4831 West Lane LLC, Local Map Amendment G-954 & Development Plan Amendment DPA 13-01

Staff Report Date: 12/7/12

Description

SHEET TITLE:
DEVELOPMENT PLAN/ AMENDMENT

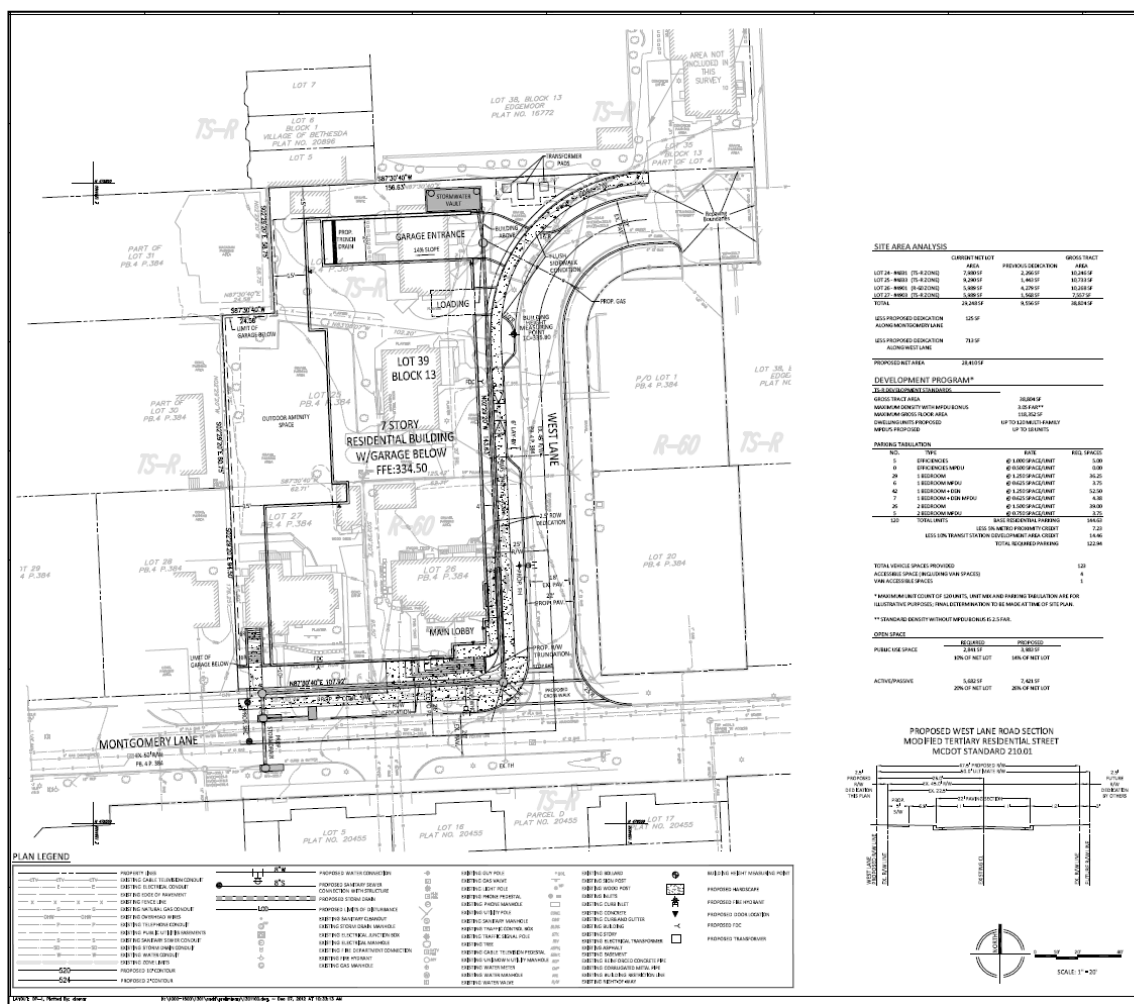
1. Drawing DP-1 shows three new transformer pads with what are assumed to be three new large transformers at grade and very prominent at the end of West Lane. We feel this would be detrimental to the streetscape and ask that consideration be given to relocating or burying the transformers. Landscaping would be a better end-view to the

2. Drawing DP-1 also shows West Lane being widened and a new curb constructed on our side of the street. However, replacement aprons serving our property are not shown. This may be early in the process to identify such details, but we feel the binding elements should include construction of new aprons on this side of the street.

Proposed Building Elevation looking north along Montgomery Lane in relation to surrounding buildings (approved but not yet built projects superimposed)

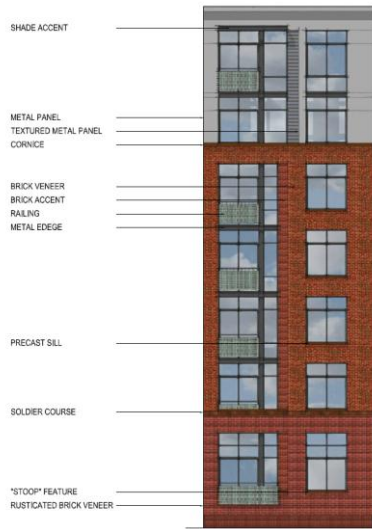
15. The final building design must include the following setbacks:
- a minimum of 15 feet from the western property line
 - a minimum of 15 feet from the northern property line.

16. Public Use Space provided along the northern property line must be accessible at grade and must include activating elements that clearly indicate the area is intended for public use.

"Before", Existing View of Montgomery Lane Looking West

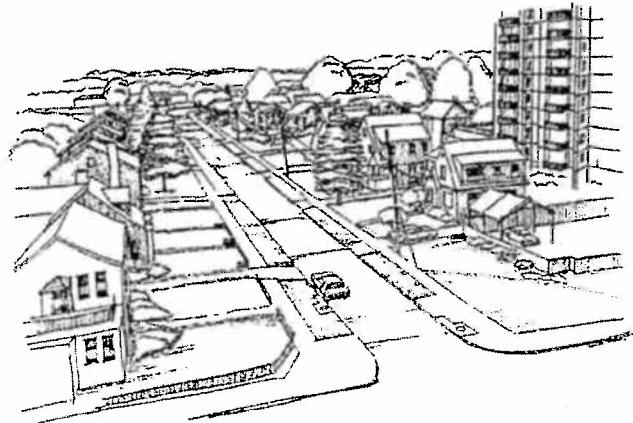
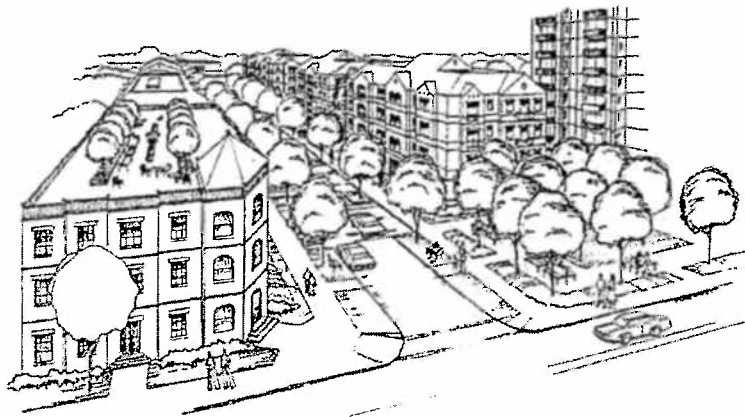
1. It is much too tall. At 70 feet, it will visually dominate the mid-block portion of Montgomery Lane.
2. It is visually much too massive. It needs more set back from the street, height along the street should be compatible with adjacent properties, with higher elements tiered deeper into the lot.
